ADDENDUM 1

TO THE DRAWINGS AND SPECIFICATIONS FOR:  
PROJECT NO. 22-22104-00

Rialto Square Theatre  
Restroom Renovation & Expansion

1 PARTIAL FIRST FLOOR ELECTRICAL PLAN - NORTH

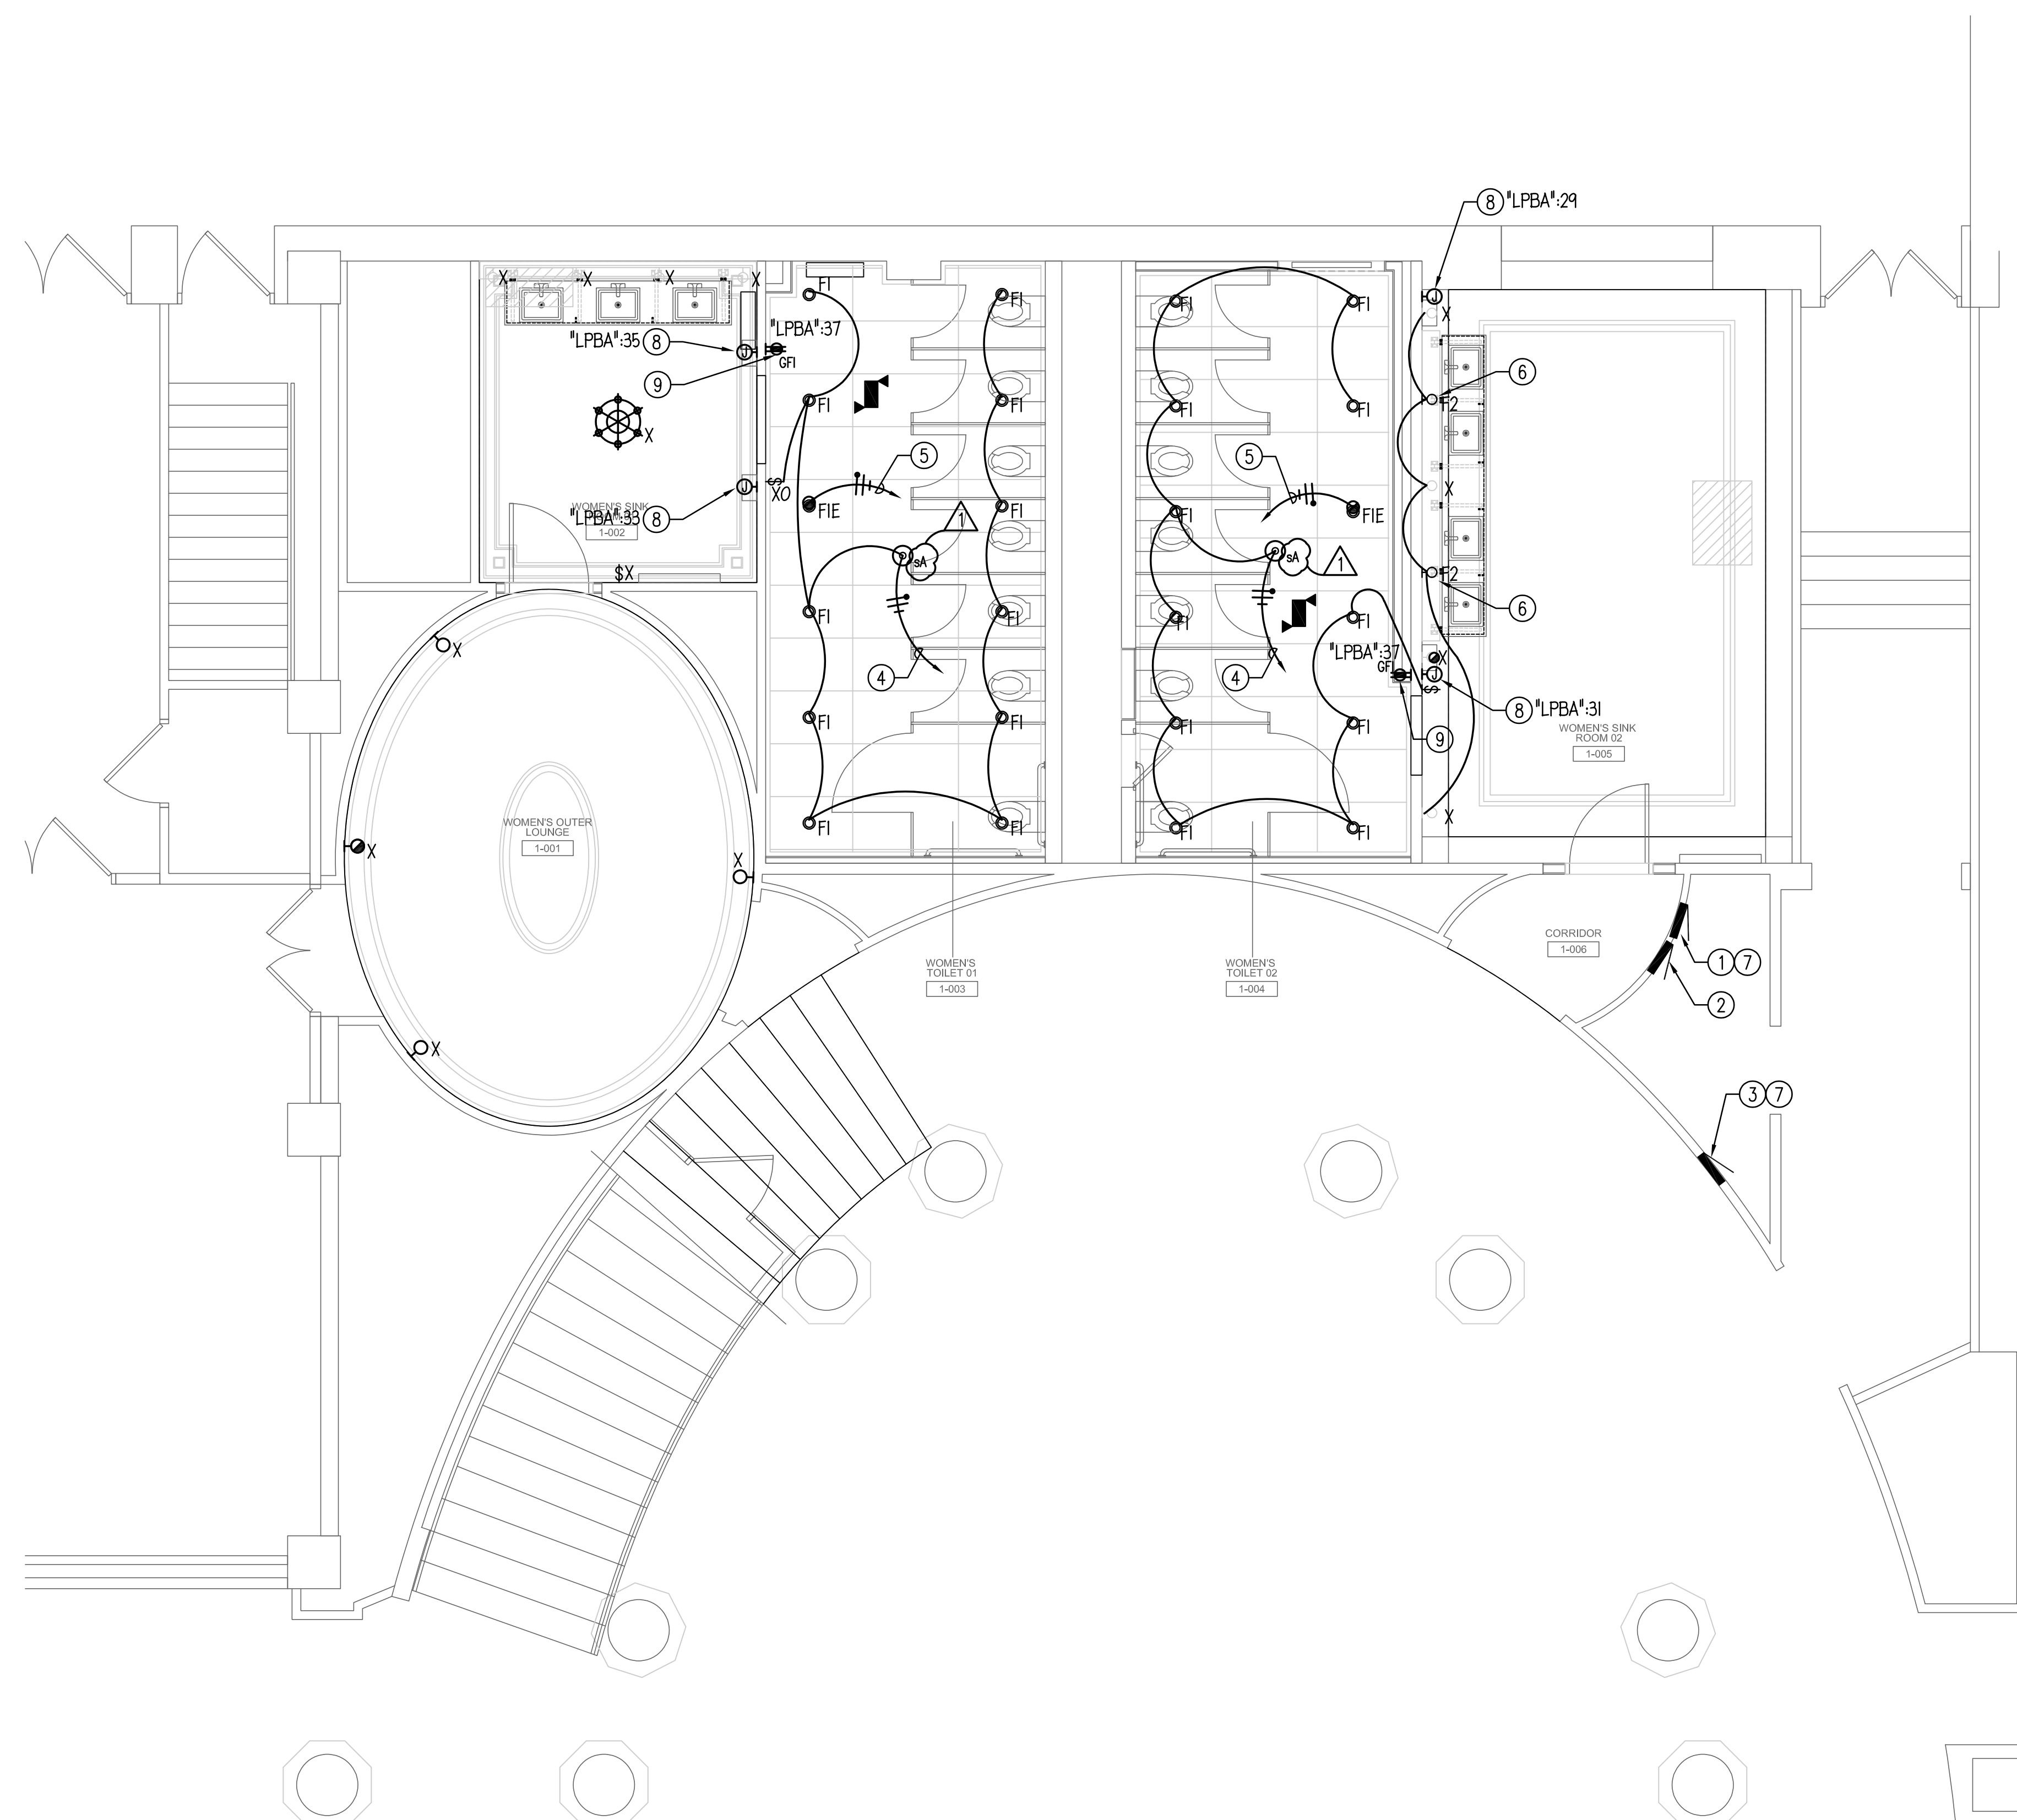
- a. Detail 1: Note added to clarify insulation on suspended sanitary piping is not required.
  - b. Detail 2: Spacing of water closets in Rooms [1-003] and [1-004] revised to be back-to-back.
- 5. Sheet E101:
  - a. Detail 1: Revised occupancy sensor type in [1-003] and [1-004]
- 6. Sheet E102
  - a. Detail 1: Added light switch to [1-008]; added emergency battery light in [1-009]

1 PARTIAL FIRST FLOOR ELECTRICAL PLAN - SOUTH  
1/4" = 1'-0"

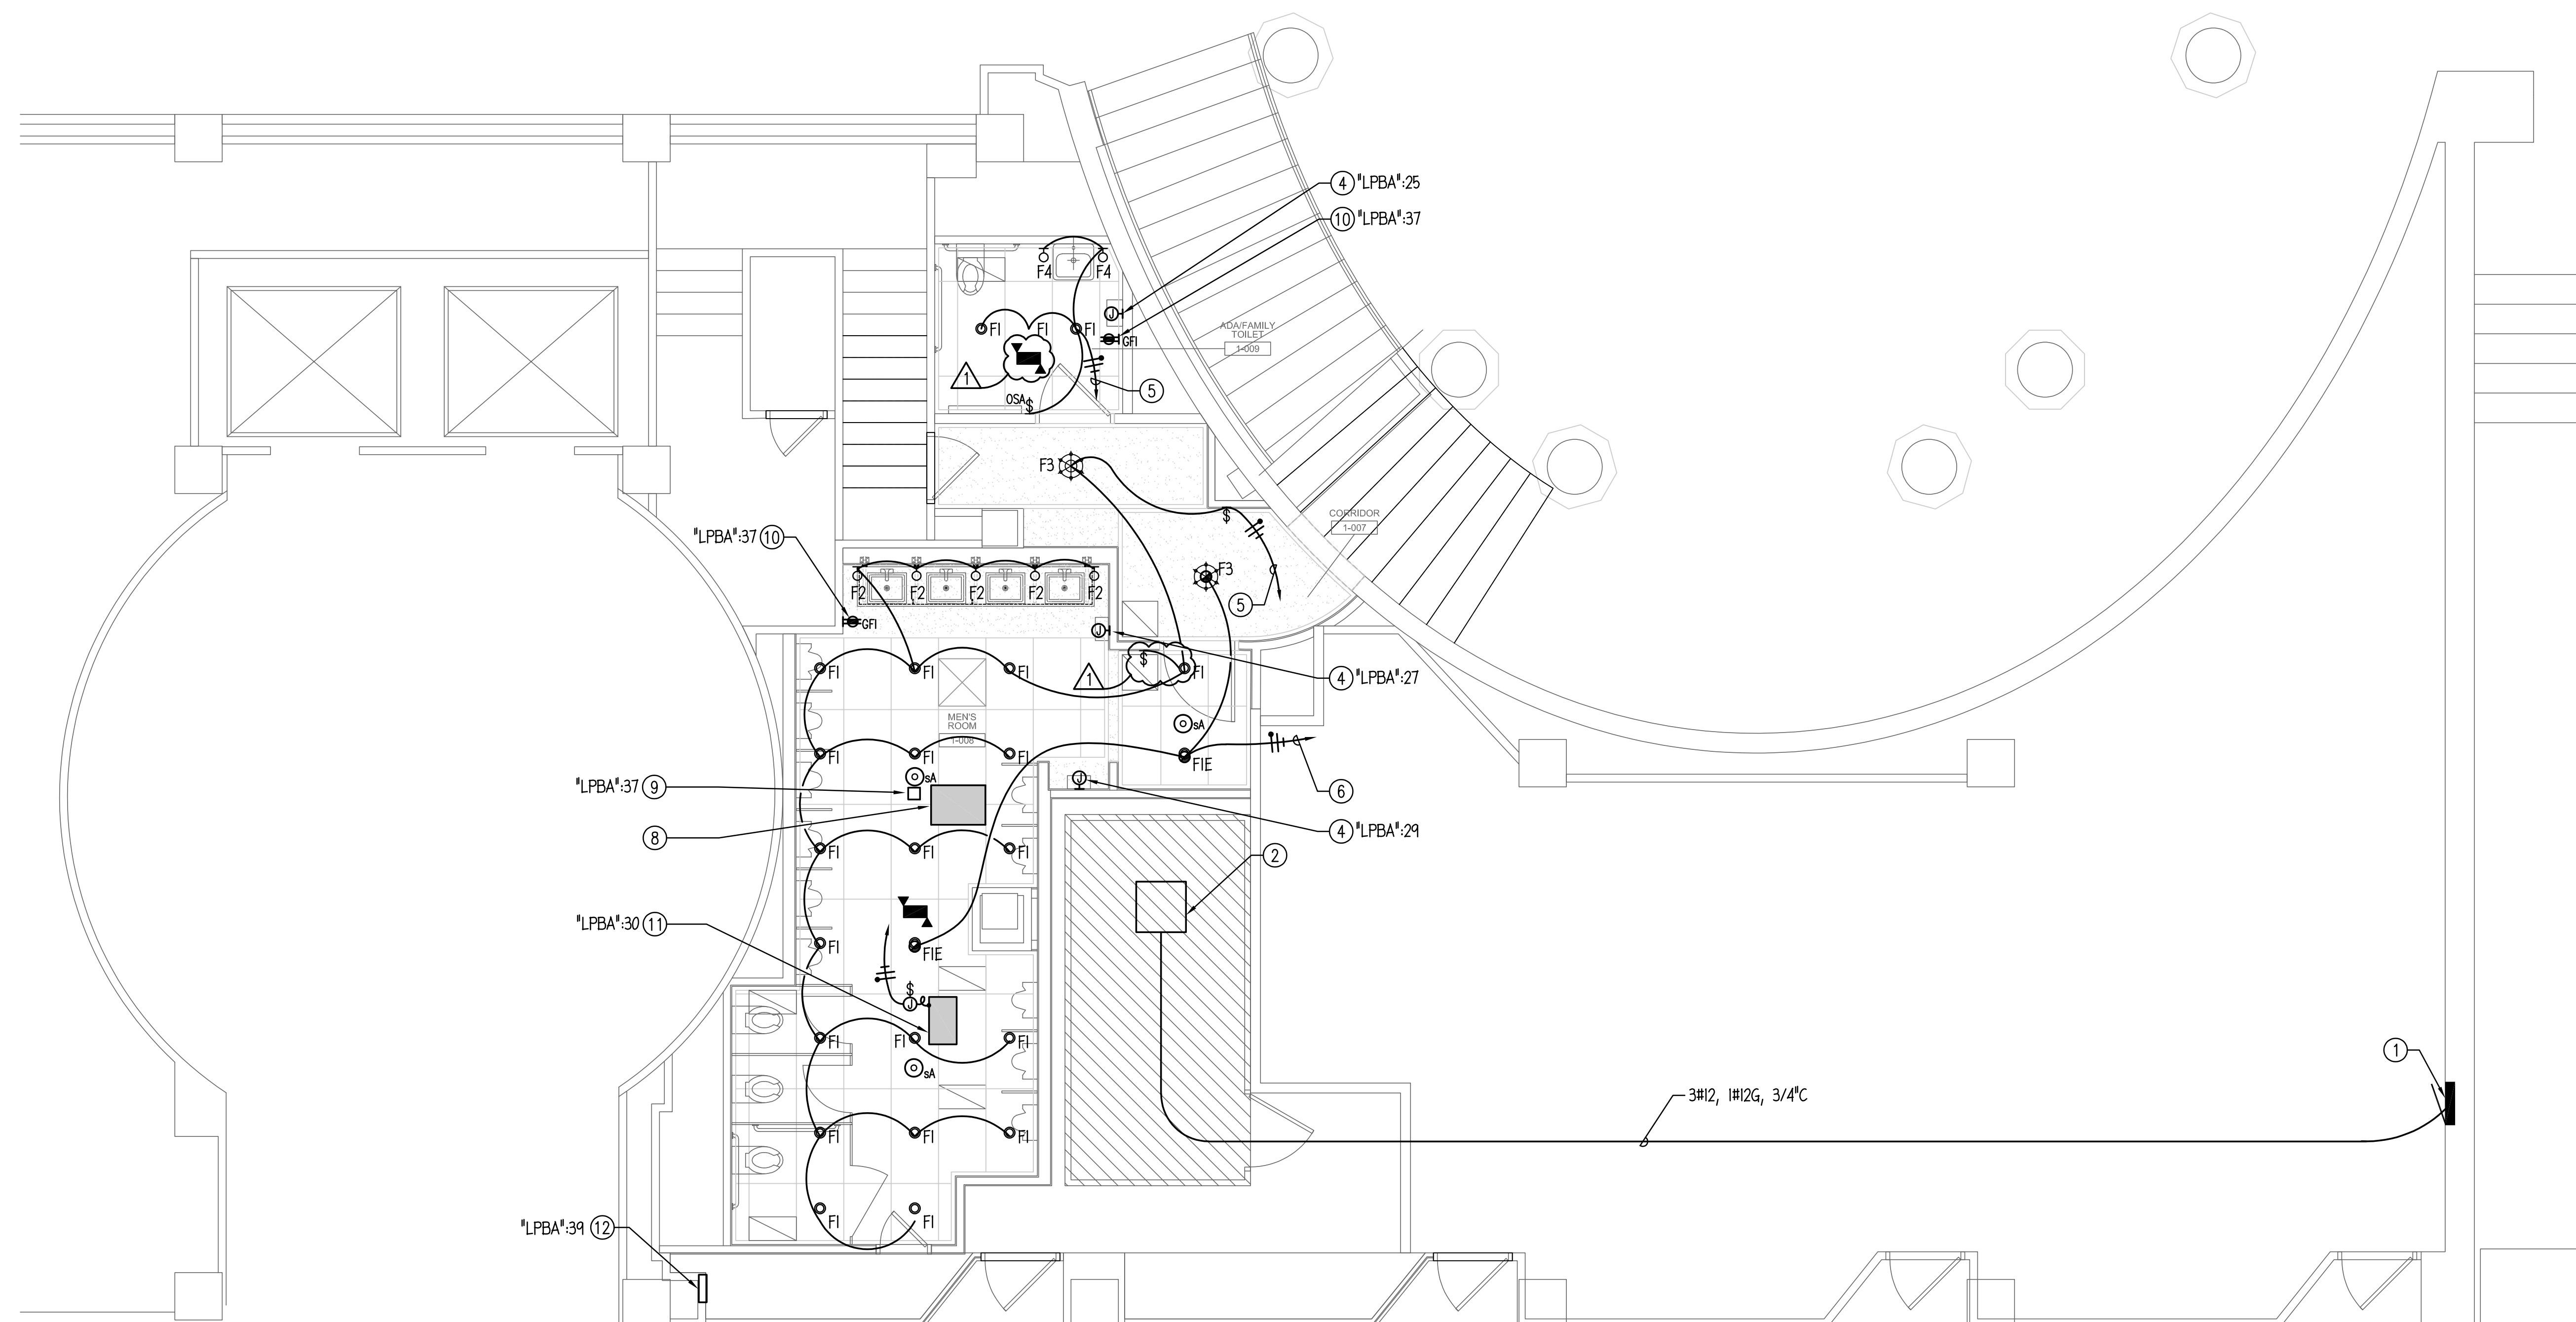
A	<b><i>The steel lintel scope of work has been removed from the contract. New opening shall be similar to that of the opening to room [1-001]. Refer to Addendum 01.</i></b>
12	Q	Please verify that insulation on PVC waste piping is necessary. The suspended horizontal piping is located in the basement.
	A	<b><i>Insulation on suspended sanitary piping is not required. Refer to Addendum 01</i></b>
13	Q	How are we controlling the lights?
	A	<b><i>Lights in ADA/Family Toilet is controlled by wall mounted occupancy sensor/switch. Lights in large restrooms are controlled by ceiling mounted occupancy sensors with a manual override light switch as indicated. - REVISE ceiling mount occupancy sensor type in Women's Toilet 01 &amp; Women's Toilet 02 to be 'sA' in lieu of 'A'. - ADD (1) new light switch to override lights in Men's Room 1-008 on latch side of door 1-008A.</i></b>
14	Q	Drawing E102 in the existing small bathroom, there needs to be an EM light in there by code.

A	<b><i>ADD (1) new emergency battery light in ADA/Family Toilet.</i></b>
15	Q	On drawings E101 and E102, the EM lights have no circuits to them. What are the circuits that need to feed these EM lights?
	A	<b><i>Emergency battery light shall be wired to local unswitch lighting circuit per schedule note #1 on drawing E201.</i></b>
